SERVICE BULLETIN

PURPOSE : CORRECTION	ISSUE NO. : MSB-11E54-514E	DATE : 2012-02-20
SUBJECT : MAIN BATTERY CAPACITY AUTOMATIC MEASUREMENT		<MODEL> (EUR) i-MiEV (HA3W) <M/Y> 12
GROUP : ELECTRIC MOTOR UNIT AND MAIN BATTERY

In Group 54 ELECTRIC MOTOR UNIT AND MAIN BATTERY, description regarding the main battery capacity automatic measurement has been incorrect. This Service Bulletin contains the correct description.

Simplified chart of main battery auto capacity measurement time

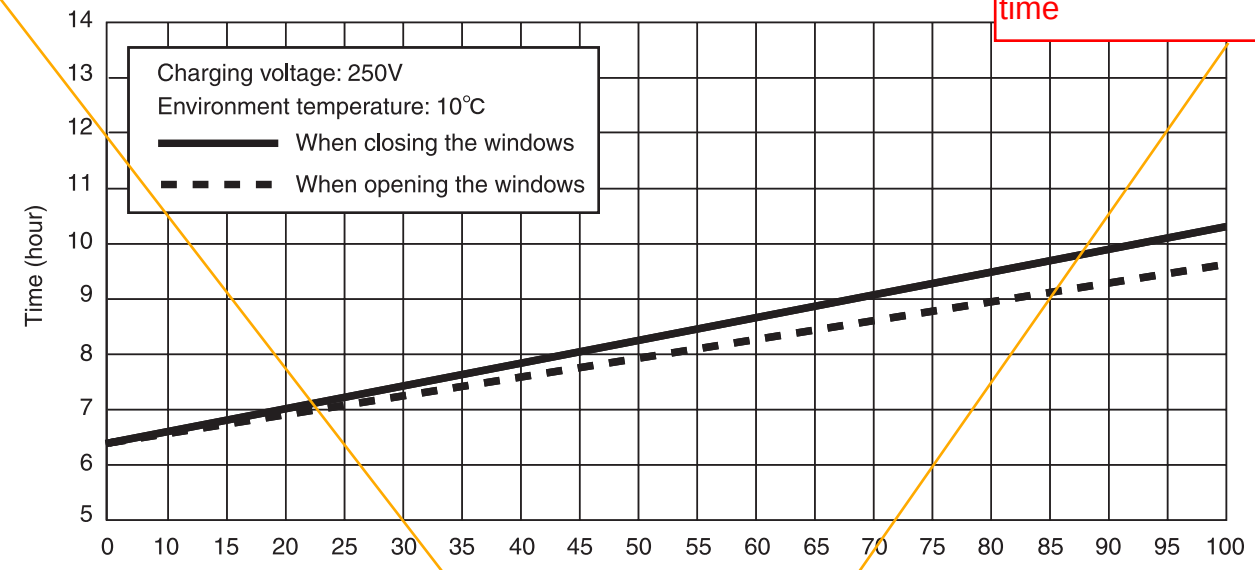
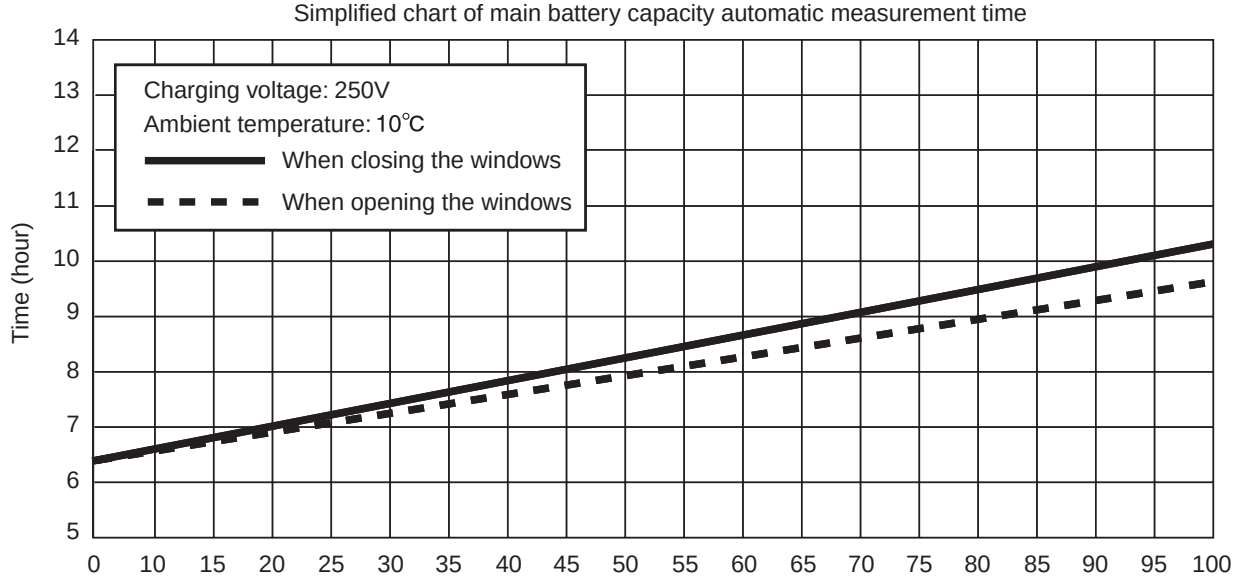
~~Simplified chart of charging and discharging time~~

NOTE: Use the data of the ~~SIMPLIFIED CHART OF CAPACITY MEASUREMENT TIME~~ as a guide.
The readings change depending on ambient temperature.

Simplified chart of main battery capacity automatic measurement time

NOTE: Use the data of the Simplified chart of main battery capacity automatic measurement time as a guide. The readings depend on ambient temperature.
